Access Audit Site Report

Prepared By
WT Group

San Angelo State Park
362 FM 2288
San Angelo, TX 76901
Accessibility Evaluation
Inspection Date: 10/05/2021
Inspectors: Tanya Scheibe

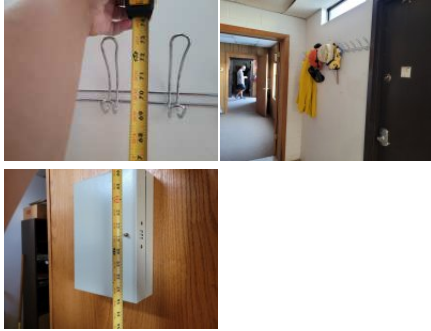
| Finding Number | Area Description | Lat/Long | Finding | As Built | Recommendation | Citation | Photos | Figure |
|----------------|---|-----------------------------|---|--|---|---|--|--------|
| 23 | Headquarters Area: Headquarters Building | [31.4545102, -100.4928 187] | Spaces and elements within employee work areas shall only be required to comply with 206.2.8, 207.1, and 215.3 and shall be designed and constructed so that individuals with disabilities can approach, enter, and exit the employee work area. Employee work areas, or portions of employee work areas, other than raised courtroom stations, that are less than 300 square feet (28 m2) and elevated 7 inches (180 mm) or more above the finish floor or ground where the elevation is essential to the function of the space shall not be required to comply with these requirements or to be on an accessible route. | south middle office-chair pull side, knob | For employee spaces, relocate storage, furniture, and other obstacles at doorways to provide approach, enter and exit at the employee space. Replace door hardware with an accessible option. | 2015 ABAAS Section: F203.9 2012 TAS Section: 203.9 2010 ADAS Section: 203.9 |  | |

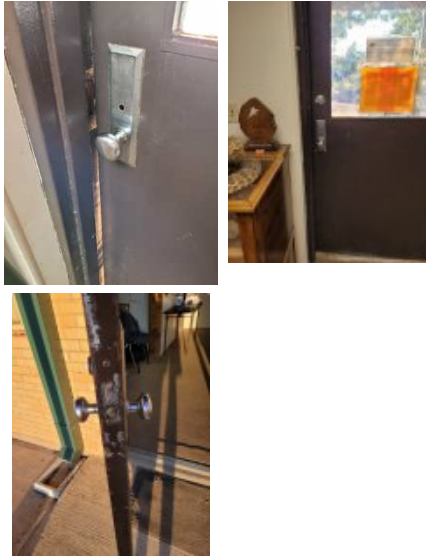
| Finding Number | Area Description | Lat/Long | Finding | As Built | Recommendation | Citation | Photos | Figure |
|----------------|---|------------------------------|---|---|--|---|---|---|
| 32 | Headquarters Area: Headquarters Building | [31.4545125 , -100.4927 919] | The restroom sign does not comply with one or more applicable requirements for the location, height, and properties of the sign. | unisex restroom- sign mounted on door | Acquire and mount signage, including Braille and access symbol mounted on wall, latch side of door, 48" to baseline of lowest character and 60" to baseline of highest character | 2015 ABAAS Section: F216.2, 703.1, 703.2, 703.5, 703.6 2012 TAS Section: 216.2, 703.1, 703.2, 703.5, 703.6 2010 ADAS Section: 216.2, 703.1, 703.2, 703.5, 703.6 |  |  |

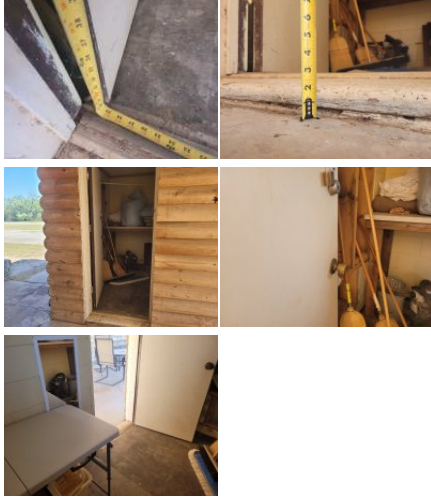
| Finding Number | Area Description | Lat/Long | Finding | As Built | Recommendation | Citation | Photos | Figure |
|----------------|---|-----------------------|---|---|---|----------------------------|--|--------|
| 84 | Lakeview Day Use Area: Lakeview Day Use Picnic Areas | [31.47434, -100.4897] | Where picnic facilities contain two or fewer picnic units, each picnic unit shall provide mobility features complying with 245.2. Where picnic facilities contain more than two picnic units, at least 20 percent, but not less than two, of the picnic units shall provide mobility features complying with 245.2. | 0 of 25 picnic areas comply, each include shelter with table, grill, nearby parking areas | Provide an AR and accessible tables to shelter/picnic area to achieve the required number accessible | 2015 ABAAS Section: F245.1 |  | |

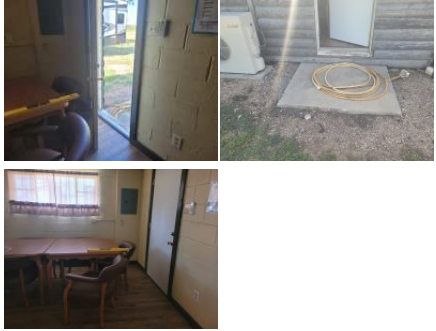
| Finding Number | Area Description | Lat/Long | Finding | As Built | Recommendation | Citation | Photos | Figure |
|----------------|--|---------------------------|--|---|---------------------------------------|--|--------|--------|
| 87 | Red Arroyo Camping Area: Red Arroyo Group Bunkhouse | [31.467803, -100.5037862] | The route of travel at this location does not provide a minimum width of 36 inches. The clear width shall be permitted to be reduced to 32 inches minimum for a length of 24 inches maximum provided that reduced width segments are separated by segments that are 48 inches long minimum and 36 inches wide minimum. | multiple points less than 36" due to furniture and beds, closet doorway 23" width | Widen AR to compliant 36" clear width | 2015 ABAAS Section: 403.5.1 2012 TAS Section: 403.5.1 2010 ADAS Section: 403.5.1 | | |

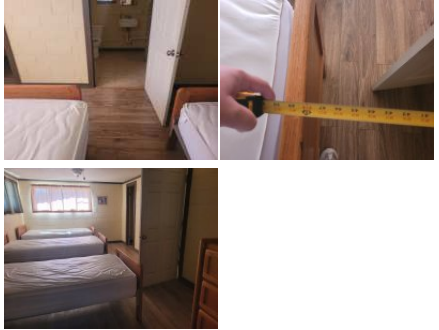
| Finding Number | Area Description | Lat/Long | Finding | As Built | Recommendation | Citation | Photos | Figure |
|----------------|--|----------------------------|---|---|---|------------------------------|---|--------|
| 98 | Red Arroyo Camping Area: Red Arroyo Group Bunkhouse | [31.4677678, -100.5037356] | <p>Picnic tables shall provide at least one wheelchair space for each 24 linear feet (7320 mm) of usable table surface perimeter. Wheelchair spaces shall be 30 inches (760 mm) minimum by 48 inches (1220 mm) minimum. Wheelchair spaces shall be positioned for a forward approach to the table and provide knee and toe clearance complying with 306 under the table</p> | width of knee clearance reduces due to supports | Replace picnic table with one of an accessible design as a smart practice | 2015 ABAAS Section: 1011.4.2 |  | |

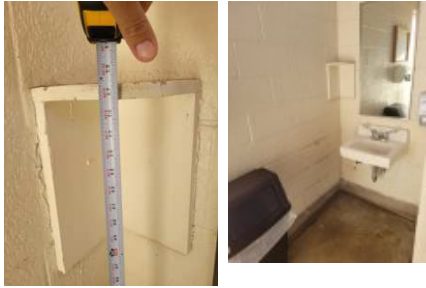
| Finding Number | Area Description | Lat/Long | Finding | As Built | Recommendation | Citation | Photos | Figure |
|----------------|---|----------------------------|--|---|--|--|--|--|
| 108 | Red Arroyo Camping Area: Red Arroyo Bunkhouse Restroom | [31.4677801, -100.5037728] | The toilet is not located within the range allowed from the side wall or partition. The centerline of the toilet must be 16 to 18 inches from the side wall. | restroom- centerline of toilet is 26.75" from side wall | Remount toilets to 16" to 18" from the side wall to centerline | 2015 ABAAS Section: 604.2 2012 TAS Section: 604.2 2010 ADAS Section: 604.2 |  |  |

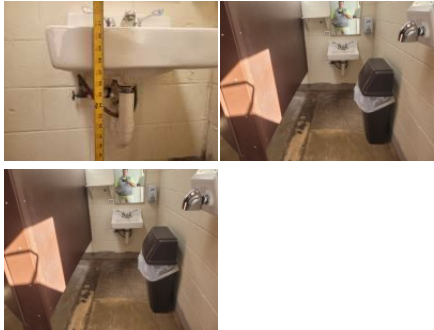
| Finding Number | Area Description | Lat/Long | Finding | As Built | Recommendation | Citation | Photos | Figure |
|----------------|--|----------------------------|---|--|---|--|---|--|
| 130 | Red Arroyo Camping Area: Red Arroyo RV Men's Restroom | [31.4639, -100.508] | The toilet is not located within the range to the side wall or partition. The centerline of the toilet shall be 17 inches minimum and 19 inches maximum side wall or partition in the ambulatory accessible toilet compartment. | centerline 25.5" from left wall, 20.5" from right wall | Remount toilet to 17" to 19" from the side wall to center line in ambulatory stalls. | 2015 ABAAS Section: 604.9.1 2012 TAS Section: 604.9.1 2010 ADAS Section: 604.9.1 |    |  |

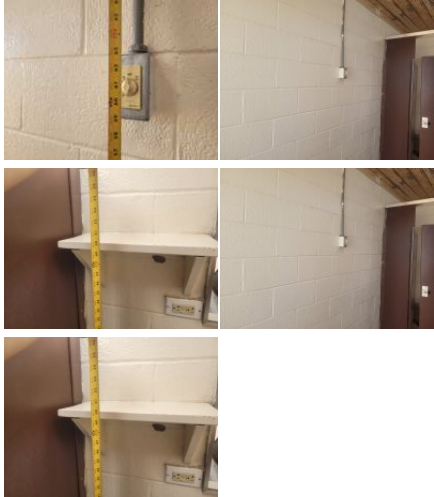
| Finding Number | Area Description | Lat/Long | Finding | As Built | Recommendation | Citation | Photos | Figure |
|----------------|--|----------------------------|--|-----------------|---|--|---|---|
| 132 | Red Arroyo Camping Area: Red Arroyo RV Men's Restroom | [31.4715914, -100.5009994] | The bench is not deep enough or long enough or is missing. Benches shall be provided having seats that are 42 inches long minimum and 20 inches deep minimum and 24 inches deep maximum. The bench shall provide for back support or shall be affixed to a wall. Back support shall be 42 inches (1065 mm) long minimum and shall extend from a point 2 inches (51 mm) maximum above the seat surface to a point 18 inches (455 mm) minimum above the seat surface. Back support shall be 2½ inches (64 mm) maximum from the rear edge of the seat measured horizontally. The top of the bench seat surface shall be 17 inches (430 mm) minimum and 19 inches (485 mm) maximum above the finish floor or ground. | 24" x 12" bench | Replace bench in dressing area with one having a seat depth of 20" to 24" deep, 42" long, affixed to the wall or having a back and mounted 17" to 19" aff | 2012 TAS Section: 903.4, 903.2, 903.3, 903.5 2010 ADAS Section: 903.4, 903.2, 903.3, 903.5 |  |  |

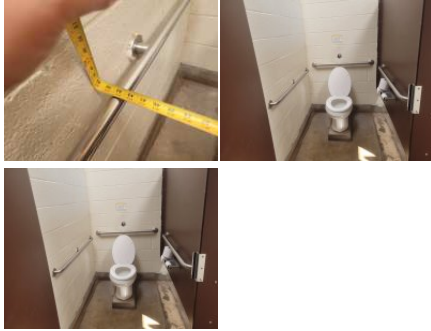
| Finding Number | Area Description | Lat/Long | Finding | As Built | Recommendation | Citation | Photos | Figure |
|----------------|--|----------------------|--|-----------------------|---|---|---|---|
| 139 | Red Arroyo Camping Area: Red Arroyo RV Women's Restroom | [31.4639, -100.508] | Transfer type shower compartments shall be 36 inches (915 mm) by 36 inches (915 mm) clear inside dimensions measured at the center points of opposing sides and shall have a 36 inch (915 mm) wide minimum entry on the face of the shower compartment. Clearance of 36 inches (915 mm) wide minimum by 48 inches (1220 mm) long minimum measured from the control wall shall be provided. | 36.25" wide, 37" deep | Enlarge transfer shower to compliant 36" by 36" clear inside dimension | 2015 ABAAS Section: 608.2.1 2012 TAS Section: 608.2.1 2010 ADAS Section: 608.2.1 |    |  <small>Total transfer shower compartment measured at the center point of opposing sides</small> |

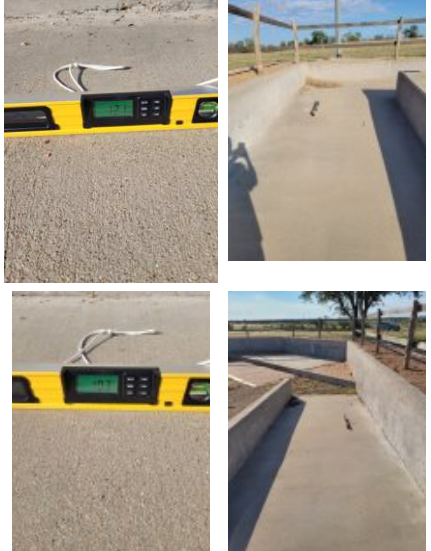
| Finding Number | Area Description | Lat/Long | Finding | As Built | Recommendation | Citation | Photos | Figure |
|----------------|---|-----------------------|--|---|--|--|--|--------|
| 226 | Red Arroyo Camping Area: Wildlife Viewing | [31.467, -100.5013] | Each distinct viewing location shall provide a viewing space adjacent to the clear ground space required by 1015.2 through which the point of interest is viewable. The viewing space shall be 32 inches (815 mm) maximum and 51 inches (1295 mm) minimum high above the ground and shall extend the full width of the clear ground space. EXCEPTION: Guards or similar safety barriers shall be permitted to obstruct the viewing space to the extent the obstruction is necessary for the guard or safety barrier to serve its intended purpose. | lower viewing areas are too high, benches located in CFS at lowered areas | Lower a 32" wide portion of railing to max 32" for unobstructed viewing as a smart practice | 2015 ABAAS Section: 1015.3, 1015.3 EXCEPTION |  | |

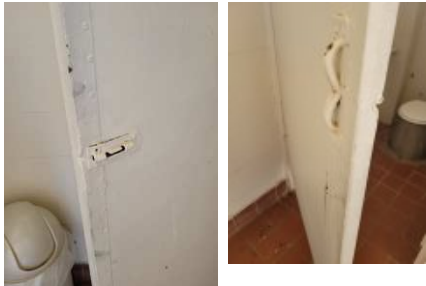
| Finding Number | Area Description | Lat/Long | Finding | As Built | Recommendation | Citation | Photos | Figure |
|----------------|--|----------------------------|---|---|---|---|--|---|
| 251 | Isabel Harte Multi-Use Area: Isabel Harte Men's Restroom | [31.4774979, -100.5044488] | The restroom sign does not comply with one or more applicable requirements for the location, height, and properties of the sign. | sign lacks Braille and raised characters, no directional sign to accessible restrooms within site | Acquire and mount signage, including Braille, mount on wall, latch side of door, 48" to baseline of lowest character and 60" to baseline of highest character Provide directional signage to nearest accessible restroom. | 2015 ABAAS Section: F216.2, 703.1, 703.2, 703.5, 703.6 2012 TAS Section: 216.2, 703.1, 703.2, 703.5, 703.6 2010 ADAS Section: 216.2, 703.1, 703.2, 703.5, 703.6 |  |  |

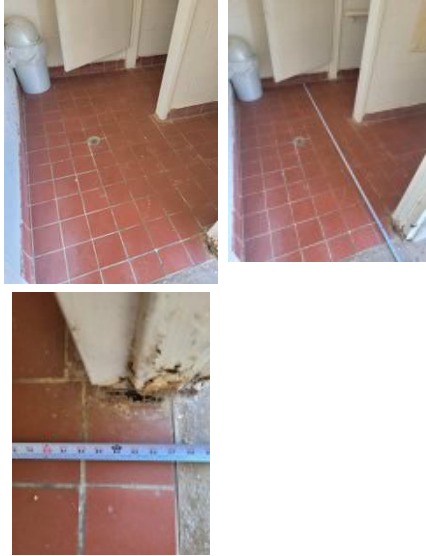
| Finding Number | Area Description | Lat/Long | Finding | As Built | Recommendation | Citation | Photos | Figure |
|----------------|--|----------------------------|---|--|---|--|---|--|
| 255 | Isabel Harte Multi-Use Area: Isabel Harte Women's Restroom | [31.4775071, -100.5044488] | This restroom is not accessible. Where existing toilet rooms or bathing rooms do not comply, directional signs indicating the location of the nearest accessible toilet room or bathing room within the facility shall be provided. Signs shall include the International Symbol of Accessibility. Where existing toilet rooms or bathing rooms do comply), the accessible toilet rooms or bathing rooms shall be identified by the International Symbol of Where clustered single user toilet rooms or bathing facilities are permitted, accessible toilet rooms or bathing facilities shall be identified by the International Symbol of Accessibility unless all toilet rooms and bathing facilities are accessible. | lacks accessible features, lacks directional signage | Restroom not accessible, acquire and mount signage directing patrons to accessible restroom | 2015 ABAAS Section: F216.8 2012 TAS Section: 216.8 2010 ADAS Section: 216.8 |   |  |

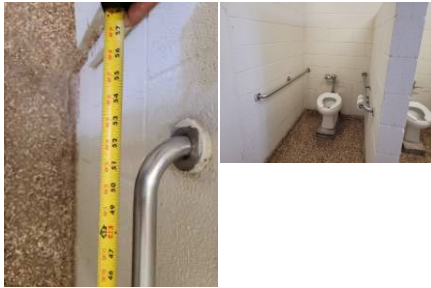
| Finding Number | Area Description | Lat/Long | Finding | As Built | Recommendation | Citation | Photos | Figure |
|----------------|--|----------------------------|---|----------------------------------|---|--|--|--|
| 393 | Bald Eagle Camping Area: Bald Eagle North Men's Restroom | [31.5415754, -100.5543137] | The drinking fountain projects more than 4 inches into the circulation path. Wall-mounted objects that have leading edges between 27 inches and 80 inches from the floor must not project more than 4 inches into the circulation path. Protruding objects that extend to the floor or within 27 inches of the floor are cane detectable and are therefore not hazardous. Where it is necessary or desirable to have objects protrude from the wall, a manner of cane detection must be provided. | protrudes 12", bottom above 27" | Relocate protruding objects or place cane detectable warning or bollard at foot of item | 2015 ABAAS Section: 307.2 2012 TAS Section: 307.2 2010 ADAS Section: 307.2 |  |  |

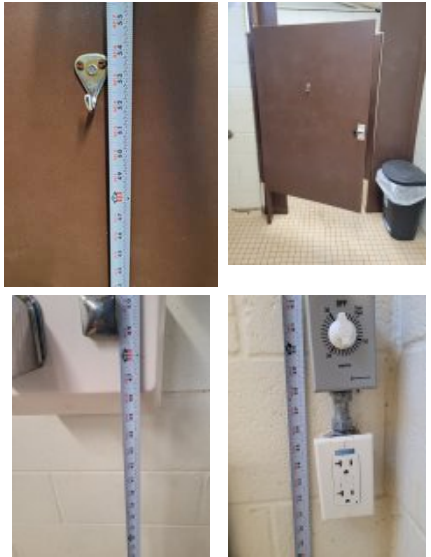
| Finding Number | Area Description | Lat/Long | Finding | As Built | Recommendation | Citation | Photos | Figure |
|----------------|---|------------------------------|--|--|---|--|---|---|
| 411 | Bald Eagle Camping Area: Bald Eagle North Women's Restroom | [31.5415789 , -100.5542 869] | The toilet paper is not installed within the compliant range in front of the toilet. Toilet paper dispensers shall be 7 inches minimum and 9 inches maximum in front of the water closet measured to the centerline of the dispenser. The outlet of the dispenser shall be 15 inches minimum and 48 inches maximum above the finish floor and shall not be located behind grab bars. Dispensers shall not be of a type that controls delivery or that does not allow continuous paper flow. There shall be a clearance of 1 1/2 inches minimum below the grab bar. | toilet paper dispenser is not installed within compliant range | Remount toilet paper dispenser max 7" to 9" from front of toilet, 15" to 48" aff and min 12" above or 1.5" below grab bar | 2015 ABAAS Section: 604.7 2012 TAS Section: 604.7 2010 ADAS Section: 604.7 |  |  |

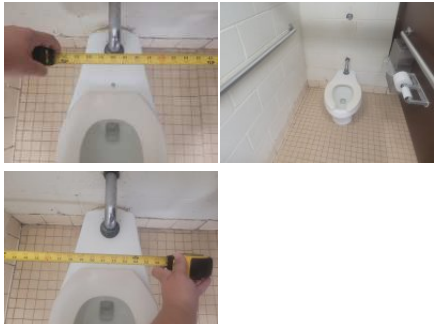
| Finding Number | Area Description | Lat/Long | Finding | As Built | Recommendation | Citation | Photos | Figure |
|----------------|--|----------------------------|---|---|---|---|--|---|
| 437 | Bald Eagle Camping Area: Bald Eagle Camp Men's Restroom | [31.5358913, -100.5442179] | Transfer type shower compartments shall be 36 inches (915 mm) by 36 inches (915 mm) clear inside dimensions measured at the center points of opposing sides and shall have a 36 inch (915 mm) wide minimum entry on the face of the shower compartment. Clearance of 36 inches (915 mm) wide minimum by 48 inches (1220 mm) long minimum measured from the control wall shall be provided. | transfer shower 36.5" x 37.25" | Correct transfer shower to compliant 36" by 36" clear inside dimension | 2015 ABAAS Section: 608.2.1 2012 TAS Section: 608.2.1 2010 ADAS Section: 608.2.1 |   |  |

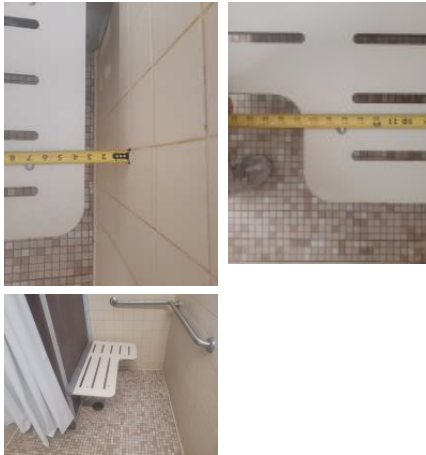
| Finding Number | Area Description | Lat/Long | Finding | As Built | Recommendation | Citation | Photos | Figure |
|----------------|--|----------------------------|--|-------------------------------------|--|---|---|---|
| 446 | Bald Eagle Camping Area: Bald Eagle Camp Women's Restroom | [31.5358981, -100.5442313] | The water and drain pipes under the lavatory are not adequately insulated. Water supply and drain pipes under lavatories and sinks shall be insulated or otherwise configured to protect against contact. There shall be no sharp or abrasive surfaces under lavatories and sinks. | pipes lack insulation | Insulate exposed pipes under one sink | 2015 ABAAS Section: 606.5 2012 TAS Section: 606.5 2010 ADAS Section: 606.5 |  |  |

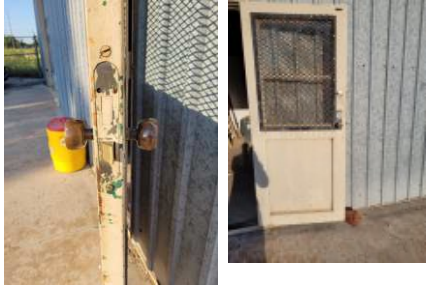
| Finding Number | Area Description | Lat/Long | Finding | As Built | Recommendation | Citation | Photos | Figure |
|----------------|--|-----------------------------|---|--|--|--|--|---|
| 466 | Bald Eagle Camping Area: Bald Eagle Playground | [31.5338726 , -100.5457226] | Play area shall have signage listing designated ages of intended users | lacks signage assumed 5-12 | Acquire and install intended user signage and mount at designated entry as a smart practice | 2015 ABAAS Section: F240.1 2012 TAS Section: 240.1 2010 ADAS Section: 240.1 |  | |

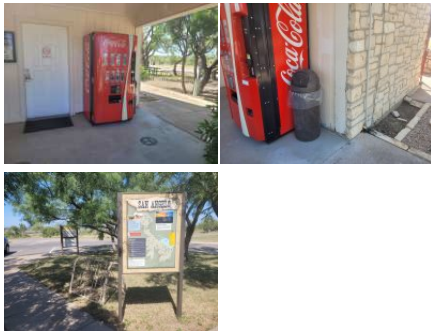
| Finding Number | Area Description | Lat/Long | Finding | As Built | Recommendation | Citation | Photos | Figure |
|----------------|------------------------------|----------------------------|---|---|--|---|---|--------|
| 480 | Employee Spaces: Maintenance | [31.4548843, -100.4928214] | Spaces and elements within employee work areas shall only be required to comply with 206.2.8, 207.1, and 215.3 and shall be designed and constructed so that individuals with disabilities can approach, enter, and exit the employee work area. Employee work areas, or portions of employee work areas, other than raised courtroom stations, that are less than 300 square feet (28 m2) and elevated 7 inches (180 mm) or more above the finish floor or ground where the elevation is essential to the function of the space shall not be required to comply with these requirements or to be on an accessible route. | trailer bay- 3.75" CIL, knob | For employee spaces, relocate storage, furniture, and other obstacles at doorways to provide approach, enter and exit at the employee space. | 2015 ABAAS Section: F203.9 2012 TAS Section: 203.9 2010 ADAS Section: 203.9 |  | |
